TO : All Bidders
FROM : Bob Lavey
PROJECT : Nogales High School Interim Locker and Restroom Portables
Project 230384.41
SUBJECT : Addendum 2
DSA : 04-123338 / File 33-13

ADDENDUM NO. 2

DRINKING FOUNTAIN - EXISTING CONDITIONS

DRAWING NUMBER: **E4.1**

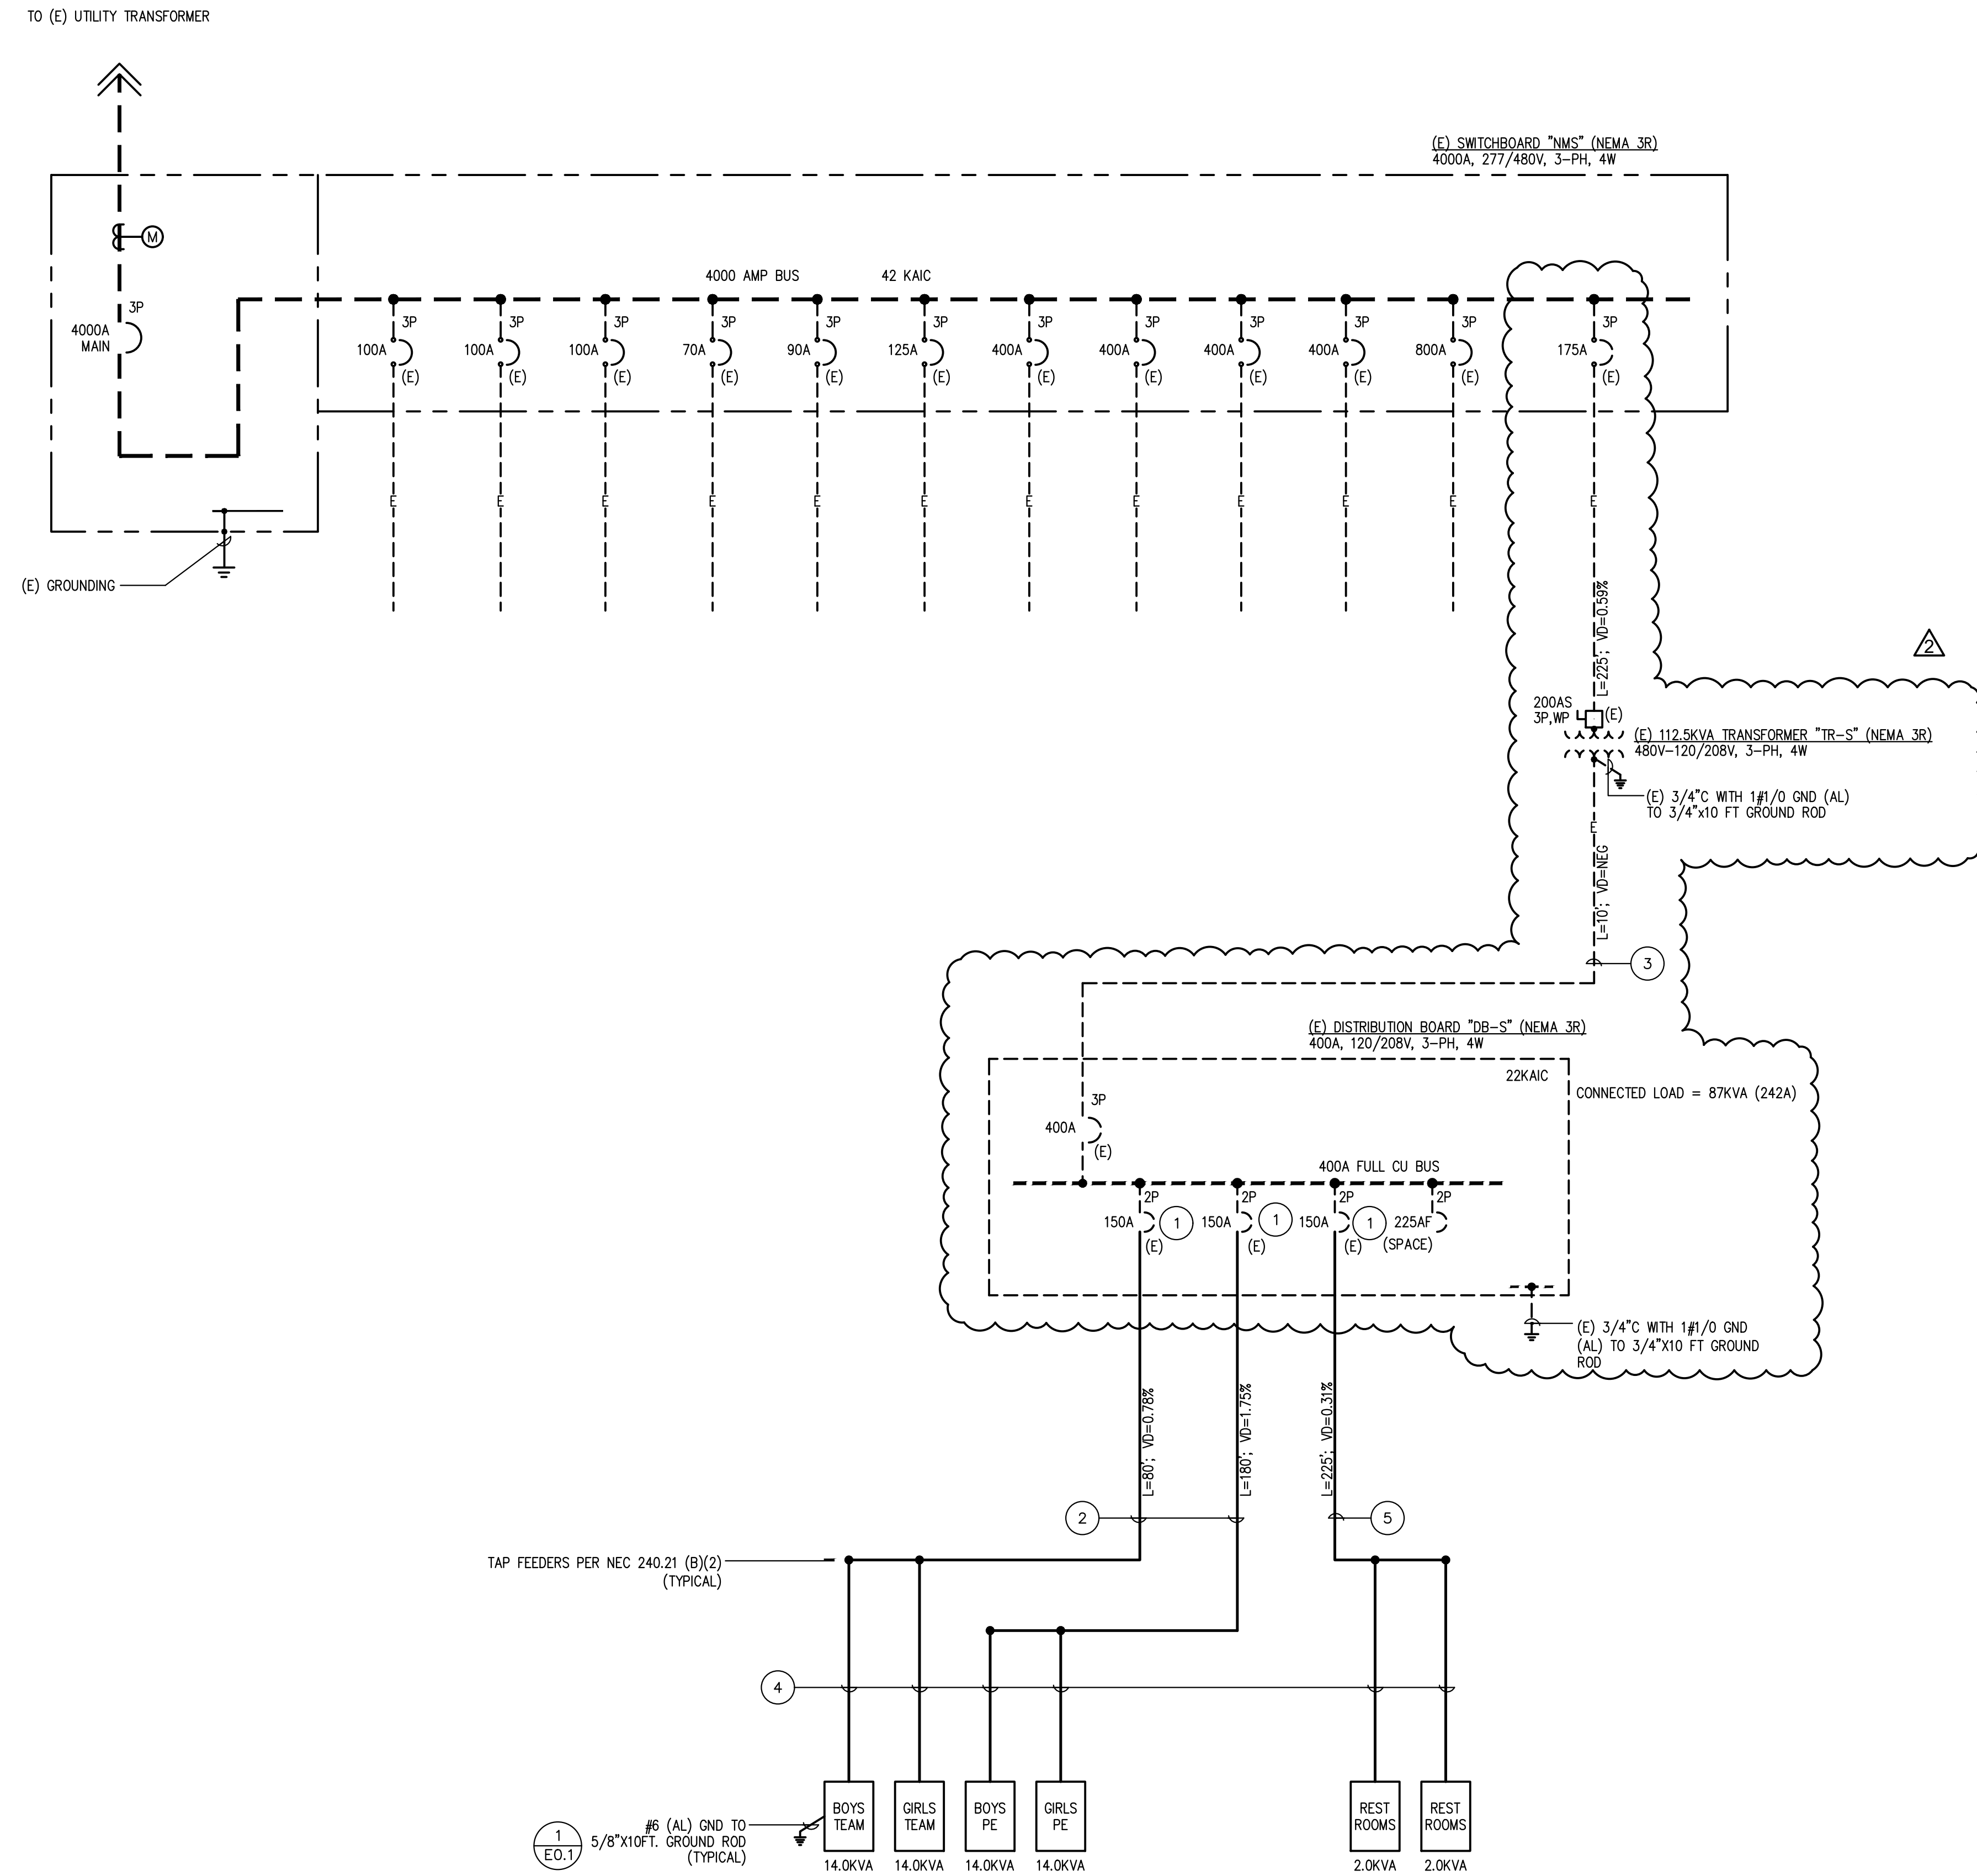
- A. Revised Single Line Diagram and revisions to reference notes 1 and 3 per the attached Drawing E4.1.
